Work Order ID 93225

Item Name: Replacement Skidtube STD w/ Training Wearplates

DRAWING NO. D3887		TITLE A119 STD SKIDTUBE ASSY		REV. B	DART AEROSPACE LTD ENGINEERING ORDER		D.E.O. NO. D3887-B-1	SHEET NO. SHEET 1 OF 1	SCALE NTS
DRAWN AJS		CHECKED 9P		MFG. APPR. 9P		APPROVED [Signature]		DE APPR. [Signature]	
DATE 12.10.29		DATE 12.10.29		DATE 12.10.30		DATE 12.10.30		DATE 12.10.30

MODIFICATION OF EXISTING DESIGN TO ALLOW INSTALLATION OF CROSSBOLT SPACERS FOR FORWARD GROUND HANDLING EQUIPMENT.

ADD THE DRILLING DETAIL BELOW TO DRILLING INFORMATION (SHEETS 5 & 6):

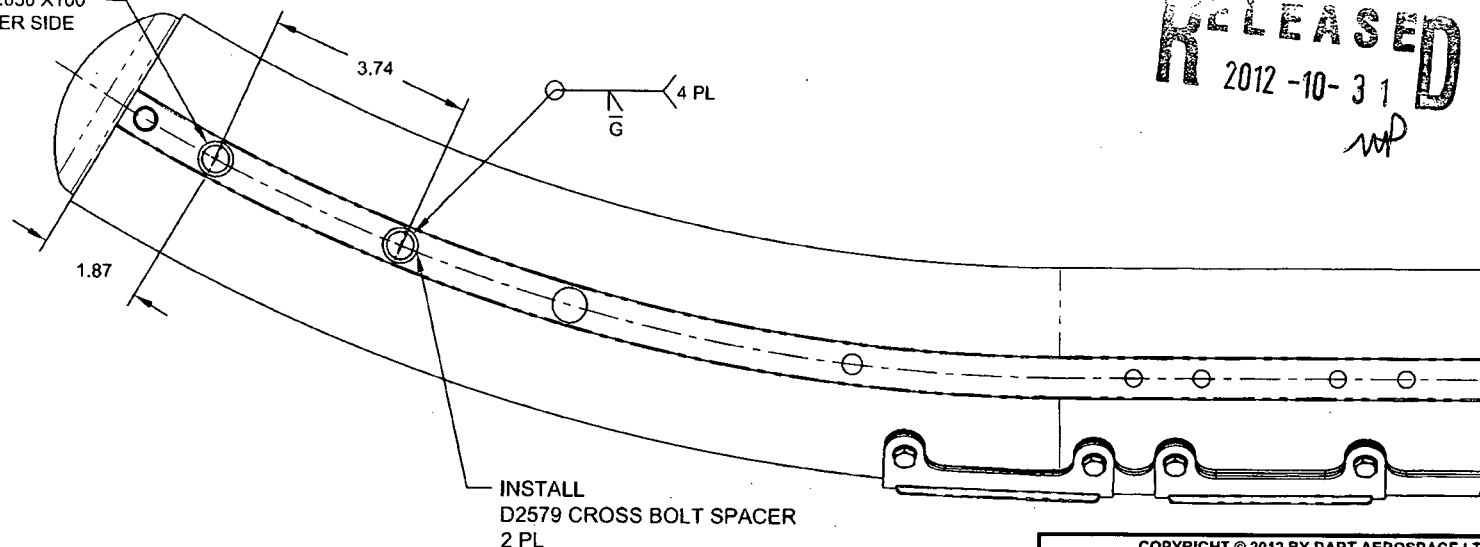
ADD THE FOLLOWING:

ADD CROSSBOLT SPACER INSTALLATION INFORMATION TO -041 THRU -045 (SHEETS 2 - 4):

DRILL Ø0.500 THRU
CSK Ø0.650 X100°
2 PL PER SIDE

FIGURE 1. MODIFIED D119-646-XXX SKIDTUBE

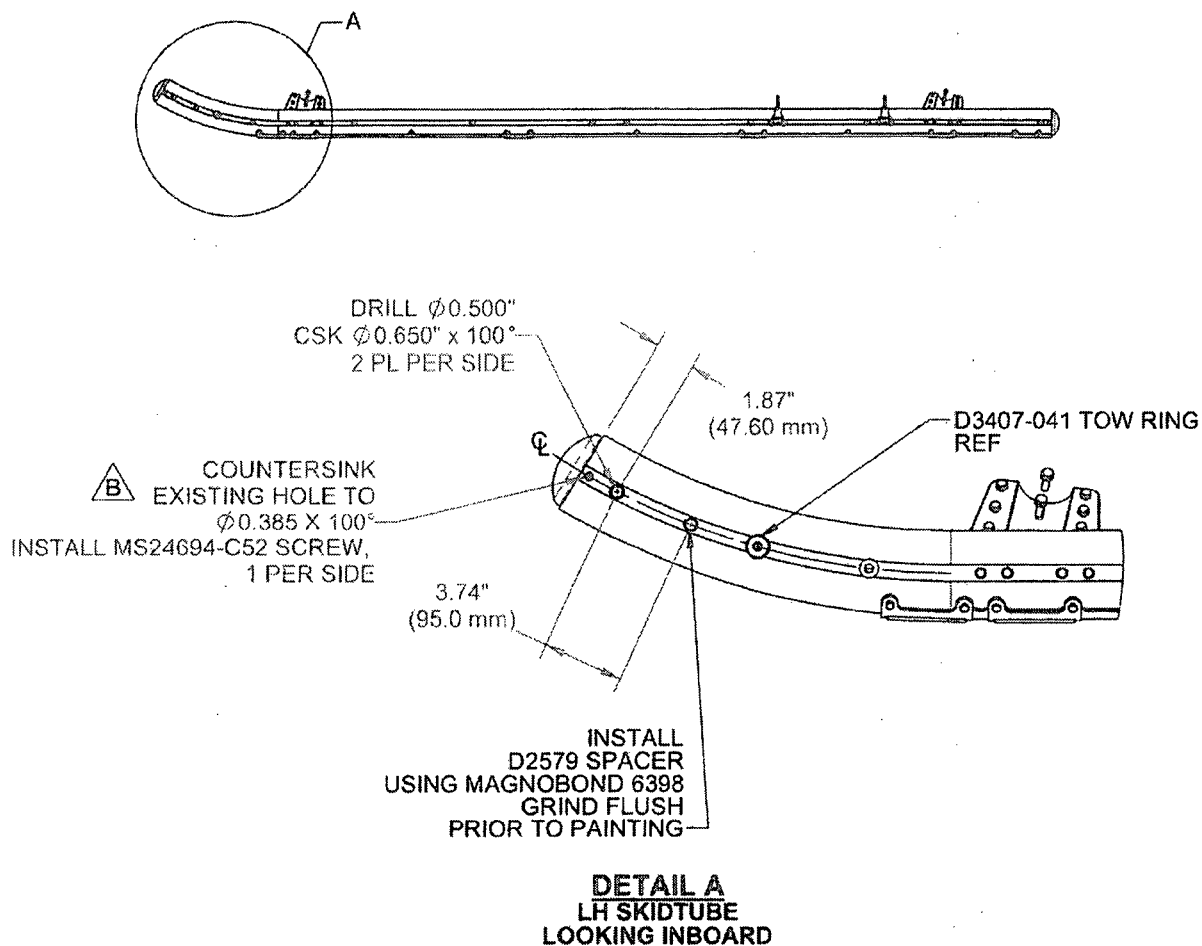
The purpose of this DSI is to provide instructions for customers to modify the forward end of the D119-646-XXX skid tubes using the DSI 9594-011 Kit to make the skid tubes compatible with the Agusta ground handling wheels. One kit modifies 2 skid tubes. After CHG 001, portions of this modification may have been incorporated in production and therefore will not need to be incorporated in the field.

B	ADD INSTRUCTION TO REMOVE EXISTING CAP MOUNTING HARDWARE AND REPLACE WITH COUNTERSUNK SCREWS	DB	13.02.20
A	NEW ISSUE	RF	12.02.03
REV.	DESCRIPTION	BY	DATE
DESIGN	RF	DART AEROSPACE USA, INC.	
DRAWN	DB	KENT, WA	
CHECKED	MB	DRAWING NO.	REV. B
MFG. APPR.	N/A	DSI 9594	SHEET 1 OF 2
APPROVED		TITLE	SCALE
DE APPR.		FWD GROUND HANDLING SPACER KIT	NTS
DATE	13.02.20	COPYRIGHT © 2012 BY DART AEROSPACE USA, INC.	
THIS DOCUMENT IS PRIVATE AND CONFIDENTIAL AND IS SUPPLIED ON THE EXPRESS CONDITION THAT IT IS NOT TO BE USED FOR ANY PURPOSE OR COPIED OR COMMUNICATED TO ANY OTHER PERSON WITHOUT WRITTEN PERMISSION FROM DART AEROSPACE USA, INC.

- 2.1 Rotate the D3407-041 Tow Ring to the vertical position as necessary.
- 2.2 Mark holes in the center ridge as shown in Figure 1. Drill through skid tube with $\varnothing 0.500"$ (12.7 mm drill), and countersunk to $\varnothing 0.650 \times 100^\circ$, two places per side.

- 2.3 Remove and discard the hardware retaining the forward Cap. Countersink the existing holes to $\varnothing 0.385 \times 100^\circ$.
- 2.4 Deburr holes. Touch up affected areas with chemical film material (Alodine 1200 or 1201) per MIL-C-5541.

- 2.5 Bond D2579 spacers into the $\varnothing 0.500$ holes center in the skid tube using Magnobond 6398. Grind flush prior painting as shown in Figure 1.
